RE: RE-ZONING AND DEVELOPMENT PERMIT APPLICATION: 1042-1044 RICHARDSON STREET

Attn: City of Victoria Planning staff (Alec Johnston):

Responses and actions taken in response to the review are addressed to each individual department in this letter, in the same order that they were presented to the applicant in the Application Review Summary (Dated October 20, 2020 and January 25, 2021). In addition to these responses, and revisions to plans, the following supplementary documents have been produced and are included in re-submission:

Figure 1: Typical bedroom elevation – North and East Elevations

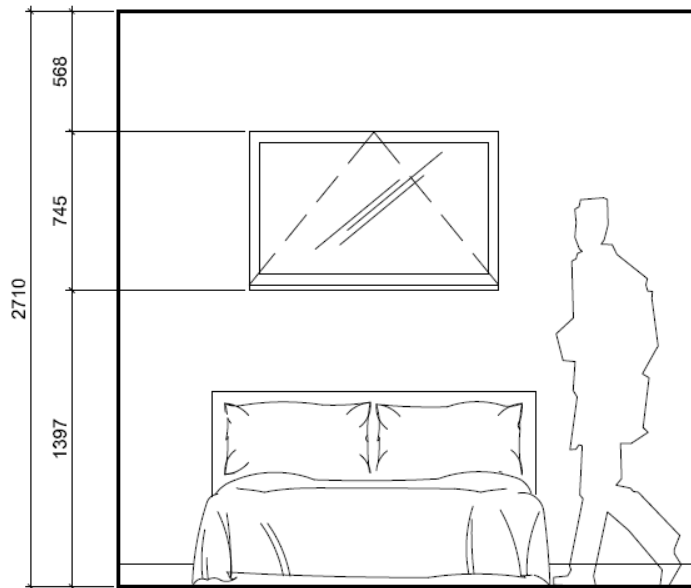
Response: Referring to Section 8.8 of the Fairfield Neighbourhood Plan (p. 77), “new development is [to be] neighbourly, compatible and transition sensitively to adjacent development, particularly adjacent Traditional Residential areas.” While this specifically references sites neighbouring traditional residential areas, and this site is surrounded by urban residential properties (multi-residential 3-4 storey structures), it is nonetheless worth explaining how this proposal is compatible to, and transitions to neighbouring developments:

- Window placements were designed to avoid overlook, as shown in the window overlay. The overwhelming majority of windows facing neighbouring properties are not designed to provide views, but rather airflow and natural light, being placed high in bedrooms (not principal living rooms). See **Figure 1**, which provided an illustration of most windows on the North and East Elevations in the plans.

1 Site Plan
1:100

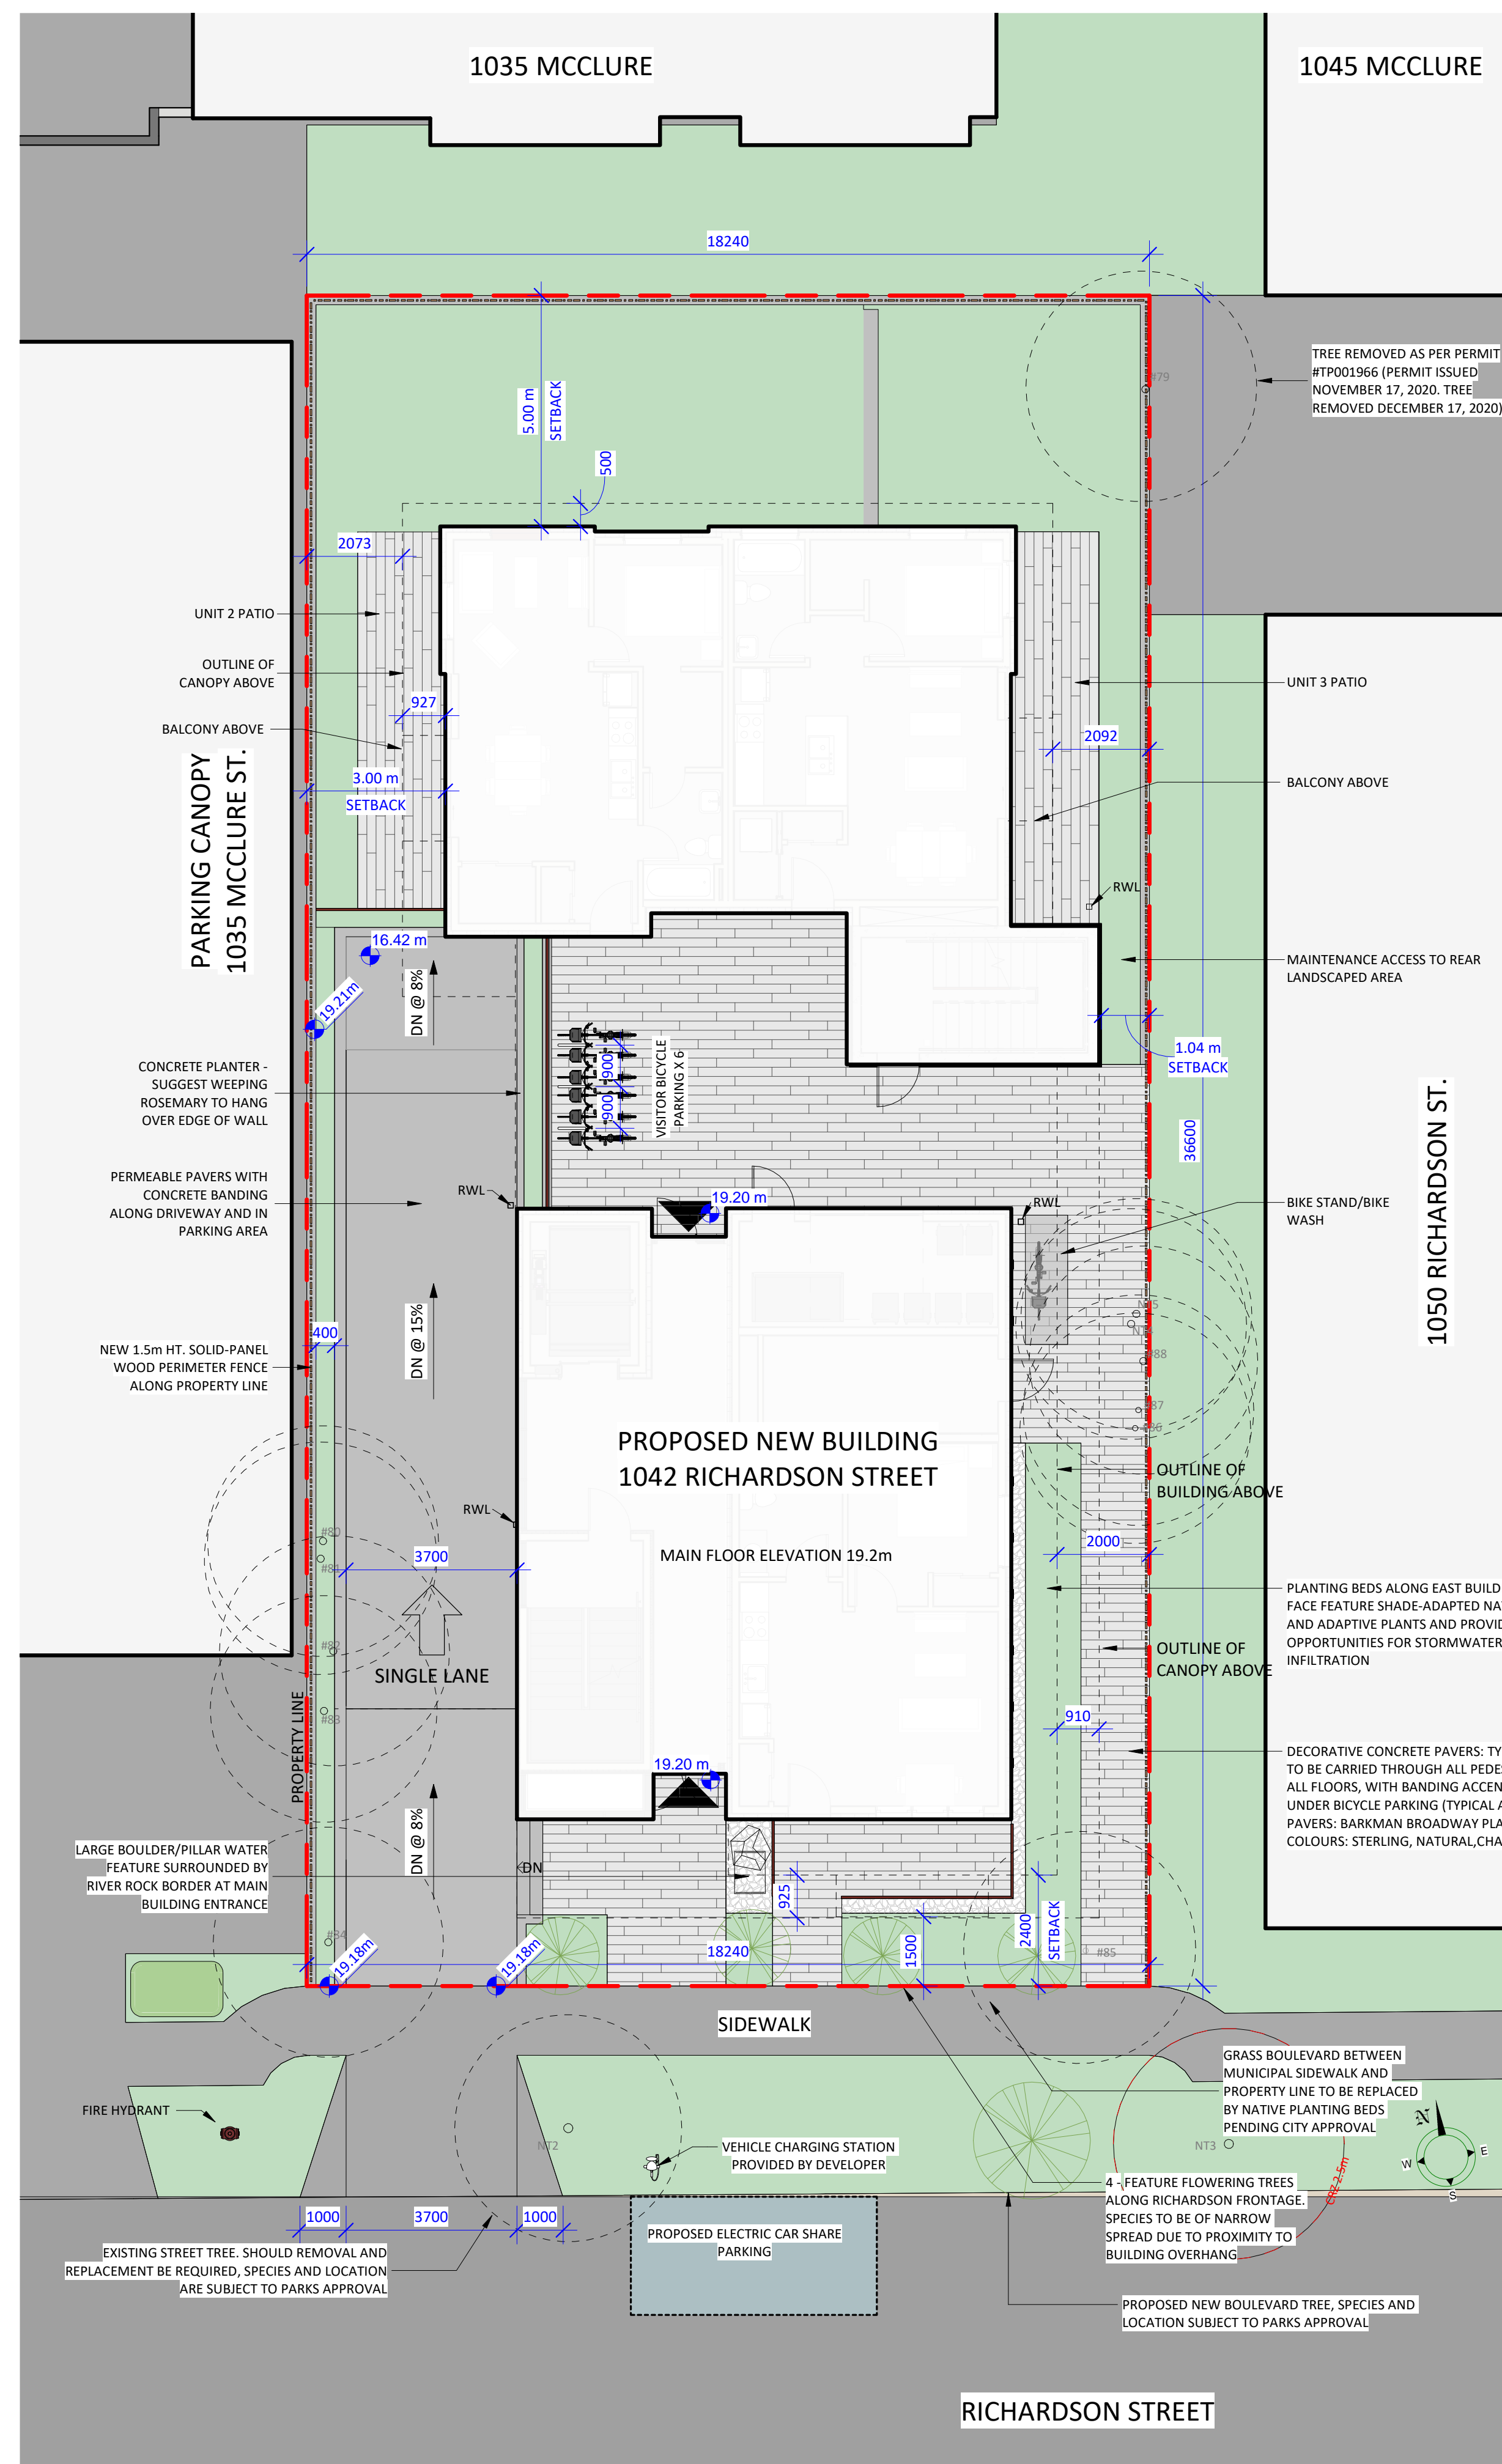
Condition #8: Site Plan: Near the south property line, the callout that references "4 feature flowering trees" to be planted. This does not match the revised plans and needs to be removed.

- **Applicant Response / Actions Taken:** The site plan has been updated to reflect landscaping changes.
